U.S. Department of the Interior  
BUREAU OF LAND MANAGEMENT

Well Name: FRED 6 FEDERAL	Well Location: T18S / R27E / SEC 6 / NWSW /	County or Parish/State: EDDY / NM
Well Number: 3	Type of Well: OIL WELL	Allottee or Tribe Name:
Lease Number: NMLC069274	Unit or CA Name:	Unit or CA Number:
US Well Number: 300153021800S1	Well Status: Producing Oil Well	Operator: REDWOOD OPERATING LLC

### Notice of Intent

## PLUG AND ABANDONMENT CONDITIONS OF APPROVAL

Redwood	PROPOSED		
Author:	Abby @ BCM		
Well Name	Fred 6 Fed	Well No.	#3
Field/Pool	Red Lake; Qn-Grbg-SA	API #:	30-015-30218
County	Eddy	Location:	Sec 6, T18S, R27E
State	New Mexico		2300 FSL & 380 FWL
Spud Date	11/28/1998	GL:	3380

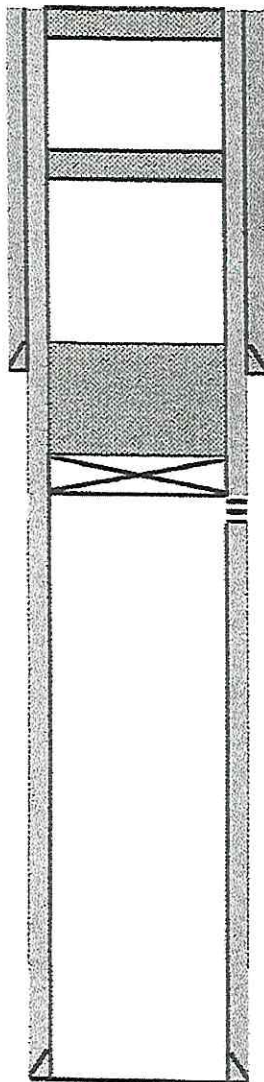
1. Set 5 1/2" CIBP @ 1436'. Circ hole w/ MLF. Pressure test csg. Spot ~~35~~ sx cmt @ 1436-~~1114~~'.  
50 sx 970'
2. Spot 25 sx cmt @ 950-650'. (Queen)
3. Spot ~~25~~ sx cmt @ ~~200~~' to surface. Verify @ surface  
50 sx 490'
4. Cut off well head, verify cmt to surface, weld on Dry Hole Marker.

3. Spot ~~26~~ sx cmt @ ~~200~~' to surface.

505x 490'

1. Set 5 1/2" CIBP @ 1436'. Circ hole w/ MLF. Pressure test csg. Spot ~~35~~ sx cmt @ 1436-1114'.  
505x 470'
